BENTON STREET
SITE ELECTRICAL PLAN
1/16" = 1'-0"

Frank West Elementary School
HVAC
Bakersfield City School District

PARTIAL SITE ELECTRICAL PLAN
SCALE: 1" = 30'-0"

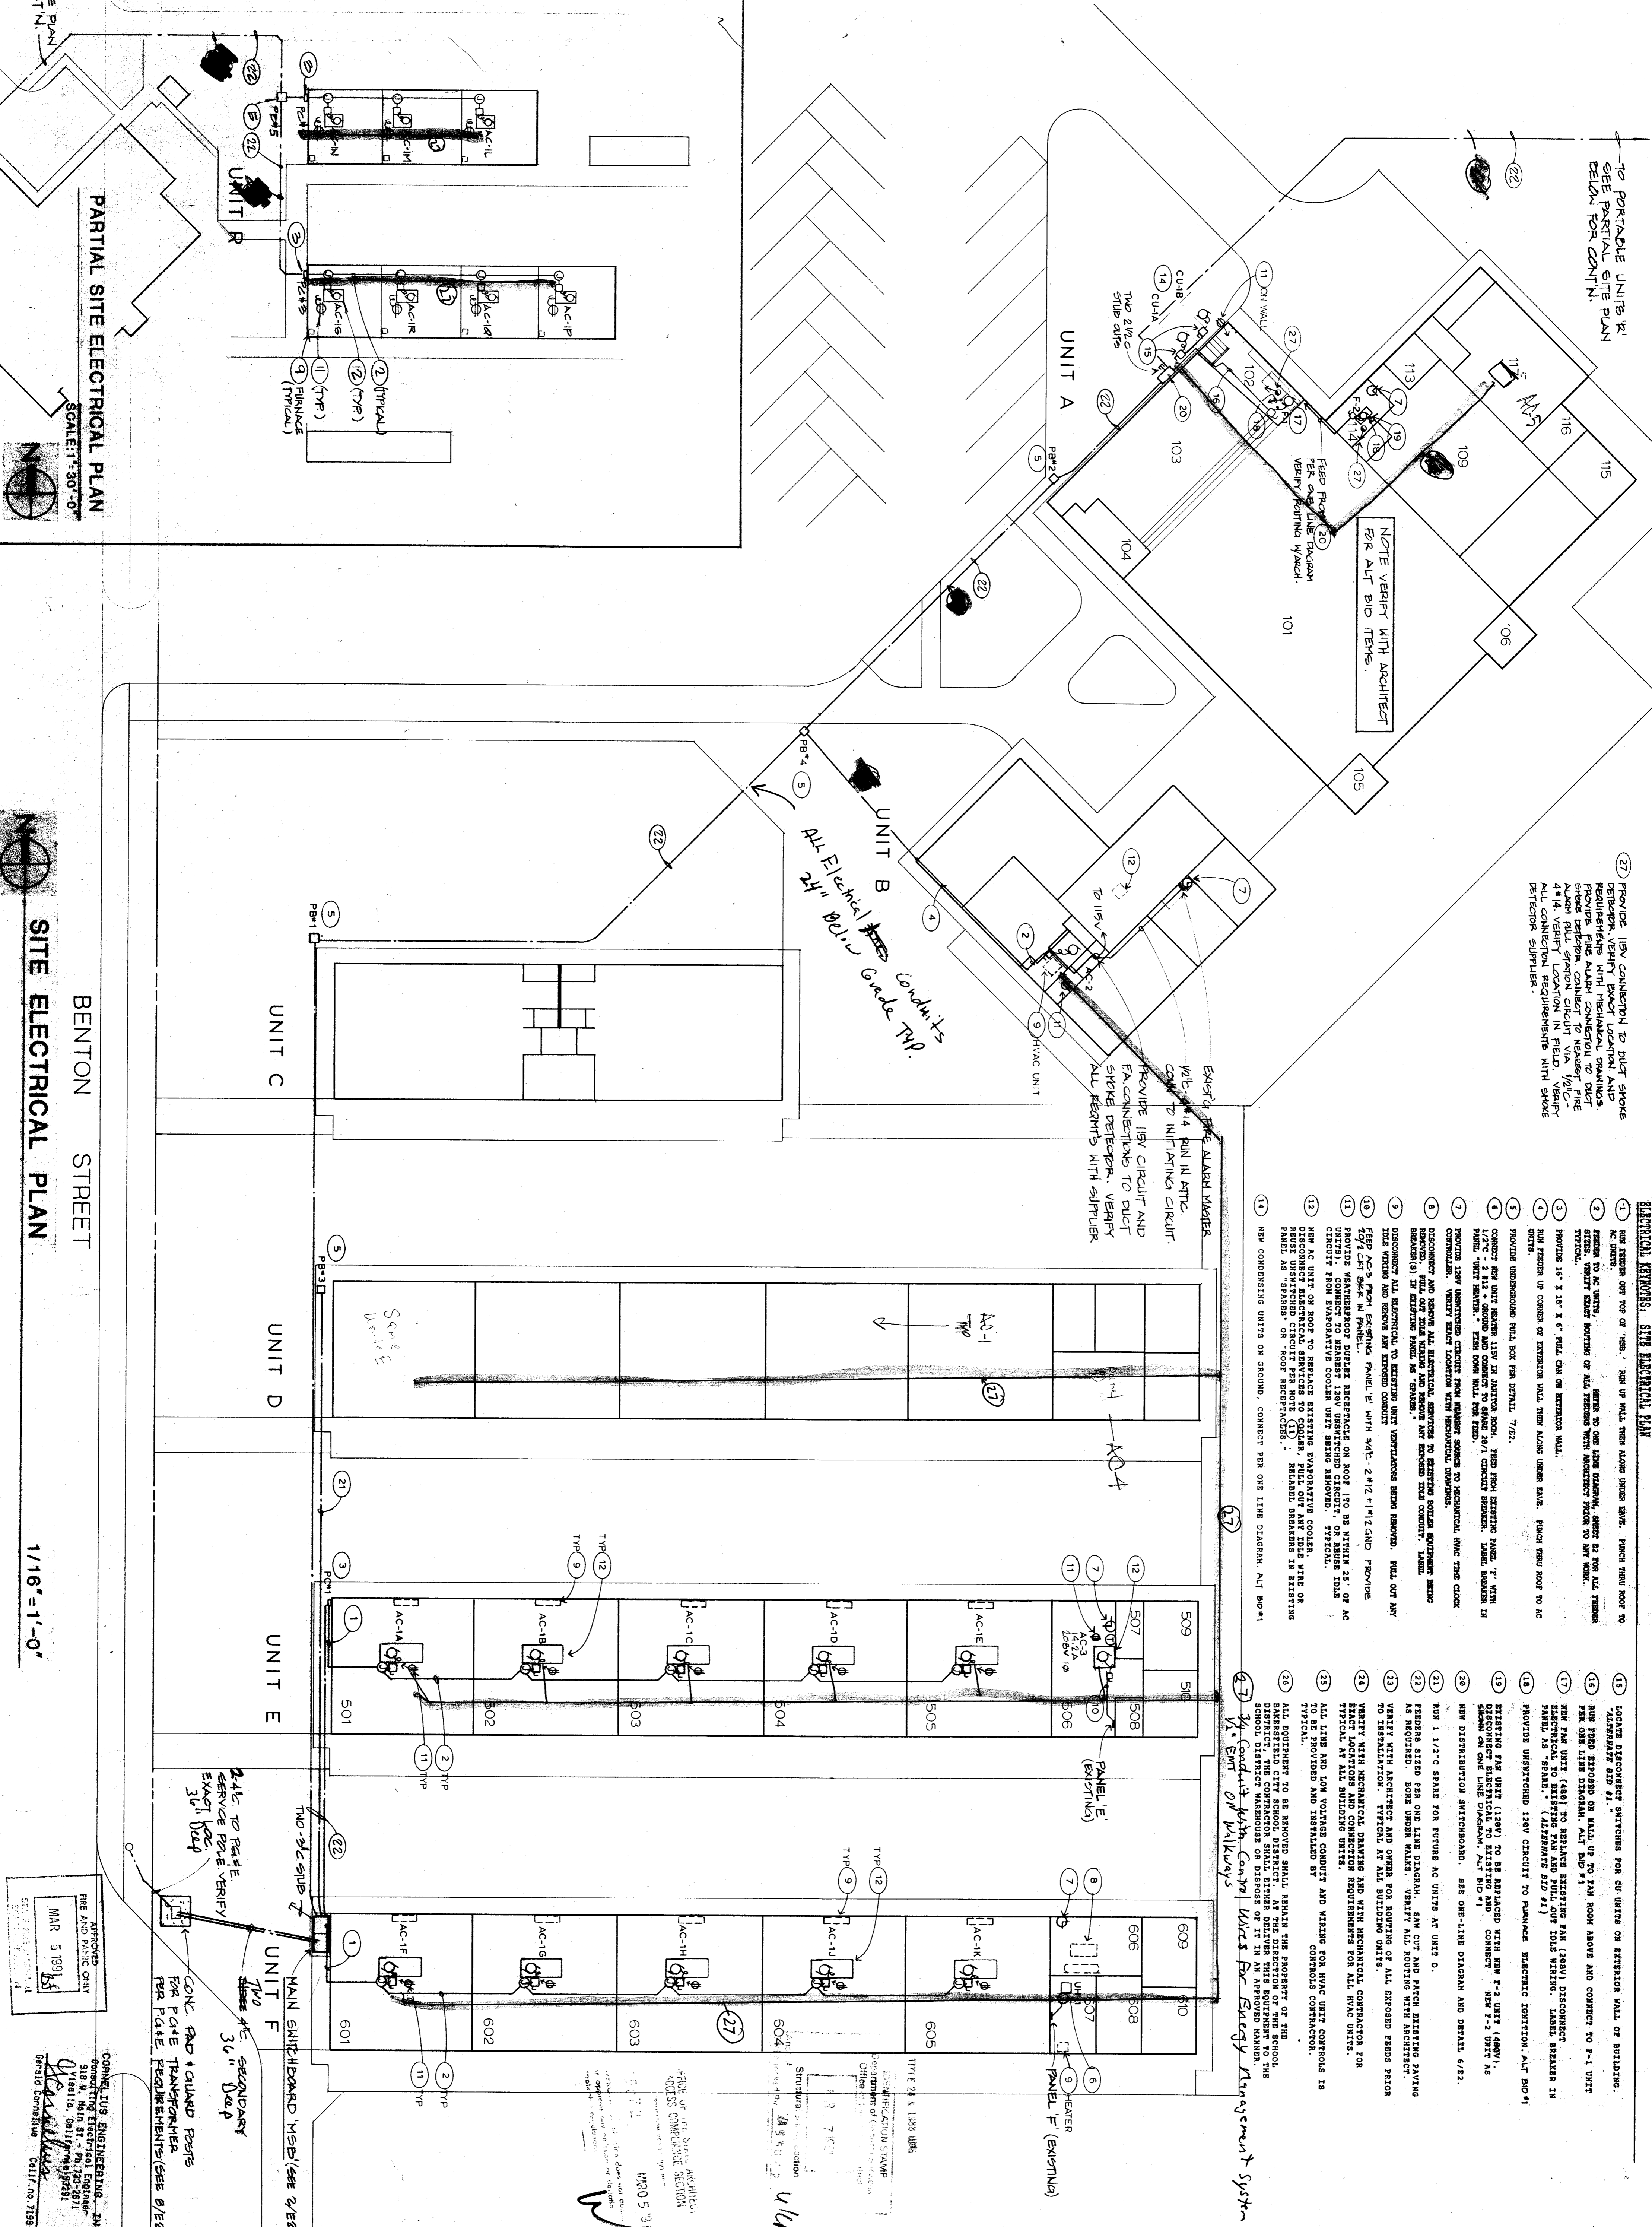
UNIT B
All Electrical ~~is~~ Conduits
24" R.O.C. Grade TYP.
